CREEKSIDE SOUTH AT LORSON RANCH PUD Development & Preliminary Plan

PCD FILE NO.: PUDSP-20-001

PUD V_7 redlines.pdf Markup Summary 8-27-2020

COVER SHEET

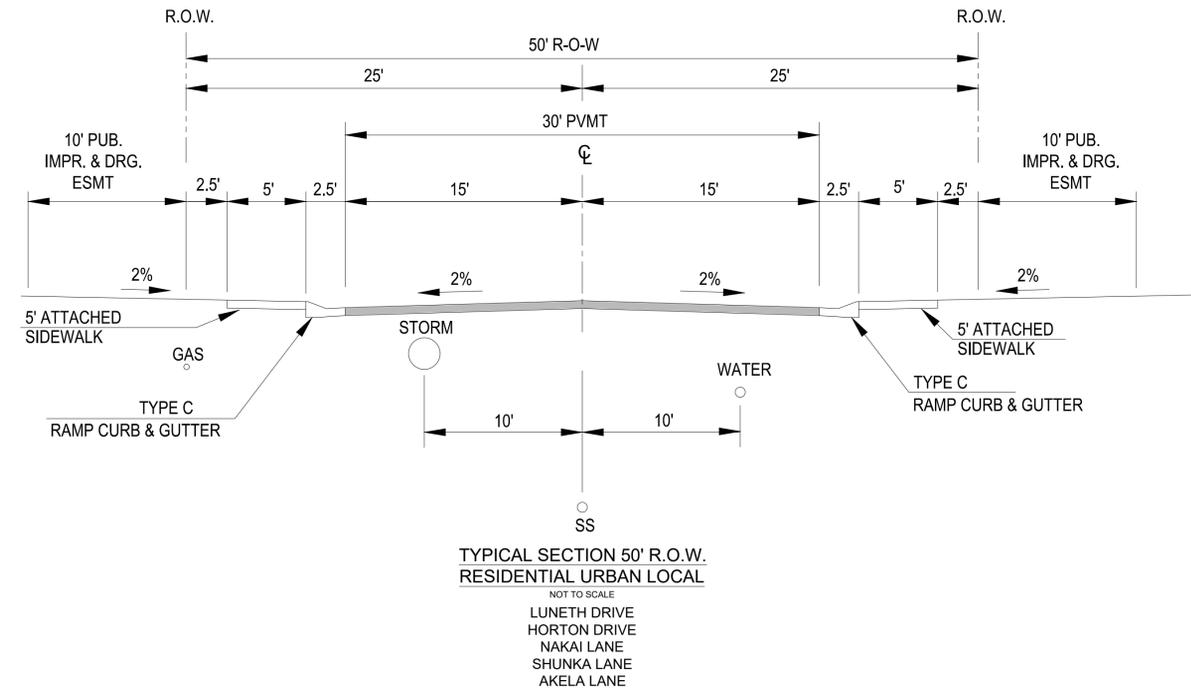
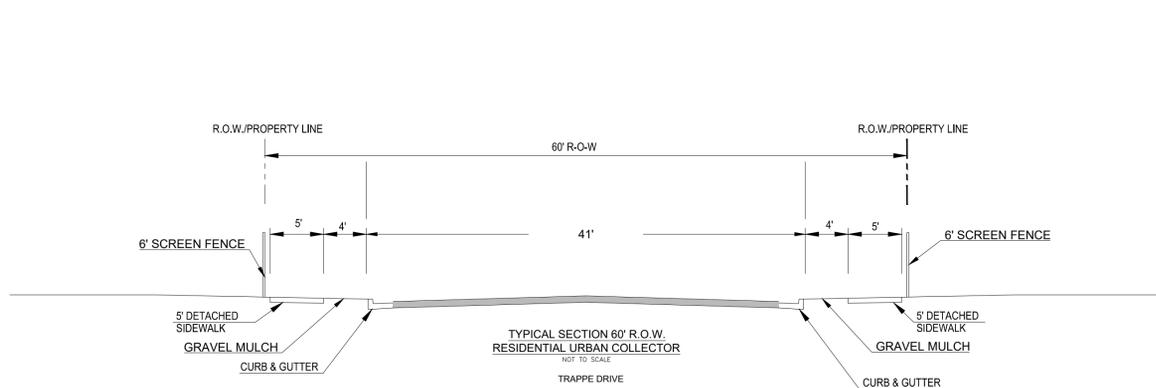
delete preliminary

see landscape comments

delete preliminary from all these docs including landscape plan set

see landscape comments

3.43 (does not include future dev tract)

delete preliminary

delete preliminary from all these docs including landscape plan set
